RECEIPT DATE: 8-13-24 **ONSITE SEWAGE DISPOSAL SYSTEM** P 586782

PROPERTY ADDRESS: 1734 Willow Springs Drive

From: Oswald Jr, Woodin <hoswald@howardcountymd.gov>
Sent: Monday, December 4, 2023 11:31 AM
To: Zach Sill <zach@sillengineering.com>
Subject: OSDS Plan_1734 Willow Springs Drive

The OSDS Plan for 1734 Willow Springs Drive has been reviewed with the following comments:

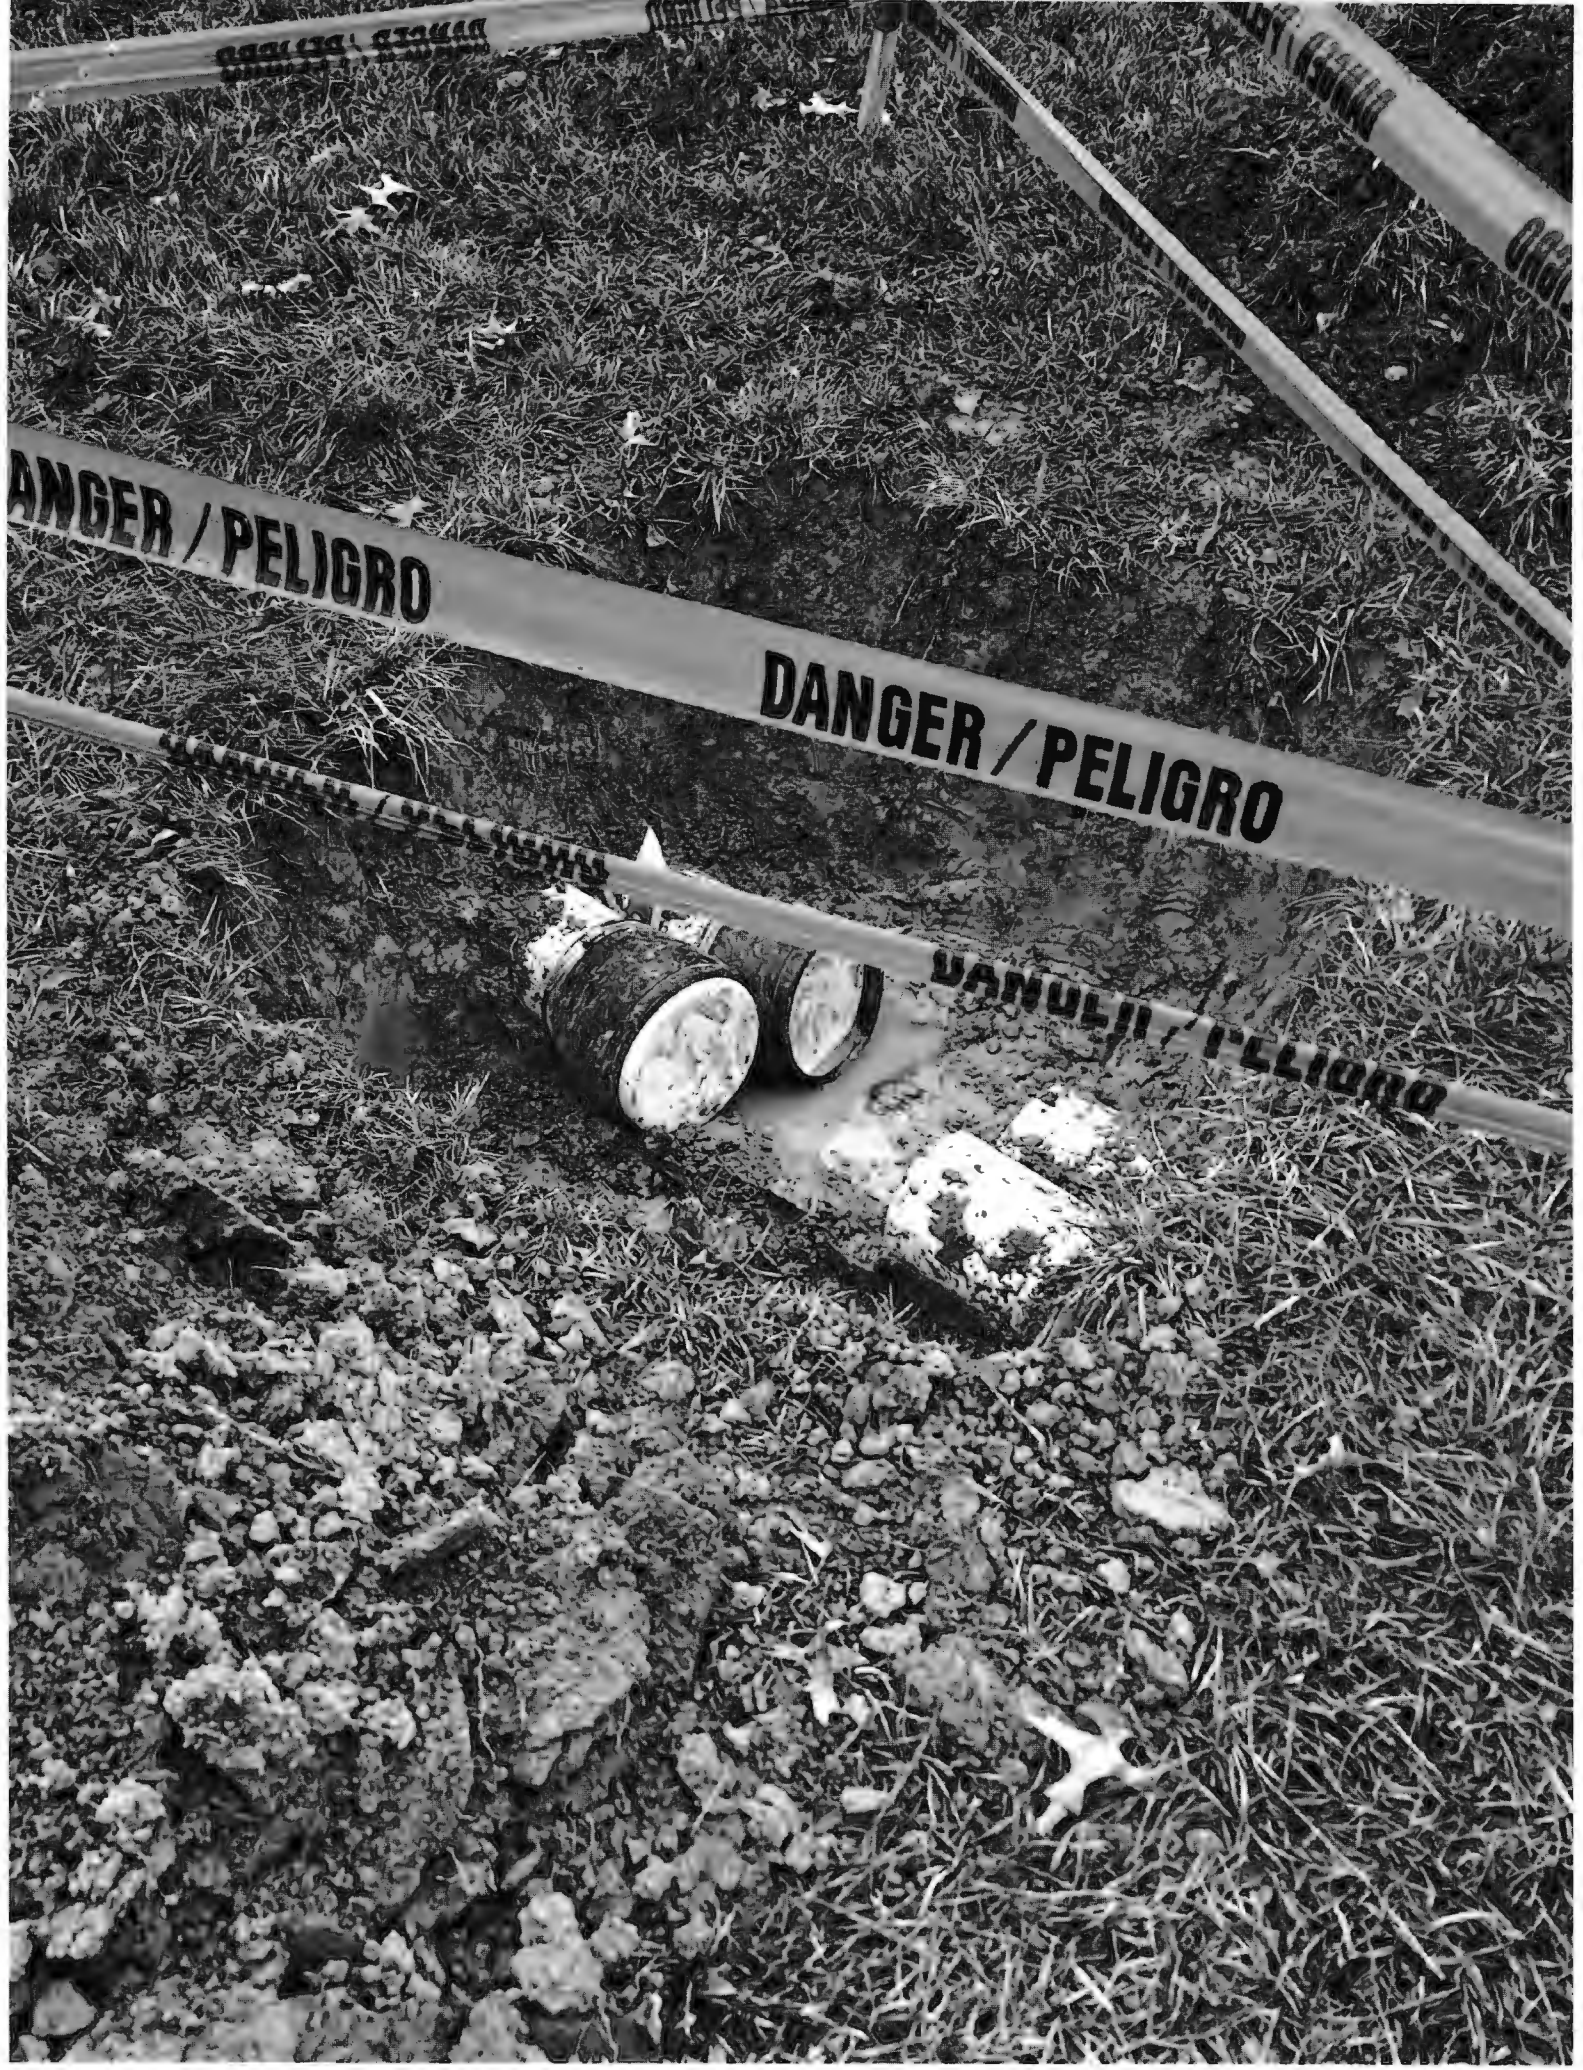
1. The last perc cert plan did not include the smaller area shown on Lot 15. If you need to utilize that area for this design, then a revised perc cert plan will be required to include that area. Trench design has been revised to keep all trenches within the SDA for Lot 13. There are no proposed trenches on lot 15 now.

2. The plan shows a 4 inch outfall and rip rap inside the SDA. Does this exist? I ask this question, because the inspector did not make note of it during the 2016 perc. A future site visit will occur to evaluate the area around the outfall/rip rap. Depending on the outcome of that visit, the area around the outfall may not be useable, and the rip rap will need to be abandoned. After extensive discussions with the county, it was determined that this is an illegal private outfall, and it is up to the homeowners to rectify. Currently, the outfall has been capped at our property line, and the neighbor will handle dealing with relocating the outfall on his property at a later date. The riprap has been labeled as "to be removed at time of installation of septic system". Please see attached photo of the capped pipe.

3. Show perc test holes on plan with elevations. Provided.
4. Show trench spacing calculation (2D+W), and proper spacing between trenches in the layout. Provided

5. Show 45 degree elbow on last turn before the septic tank. Alignment has been adjusted before the septic tank to make a more gradual turn into the septic tank.

6. Label cleanouts on plan. Cleanout labeled with "C/O"
7. You could make the 1st replacement system 2 – 100 ft. trenches to allow enough room to fit the 2nd replacement system in the lower portion of the SDA. Trench design has been revised.

8. How did you arrive at 111.0239 CF or 830.516 excess above the high water alarm? Are you including the space above the pump tank invert? We include the area between the High Water alarm and the Invert in.

9. Eliminate 90 degree angles in FM at stream. Make FM gradually slope down to stream and up to d-box for a smoother transition. Show sleeve on FM at stream with sleeve extending out 10 feet on both sides of stream. These are 1/8 bends at stream. Sleeve has been provided in profile view and called out as "proposed sleeve extending 10' on both sides of the stream centerline and is noted under "OSDS Notes" on sheet #2.
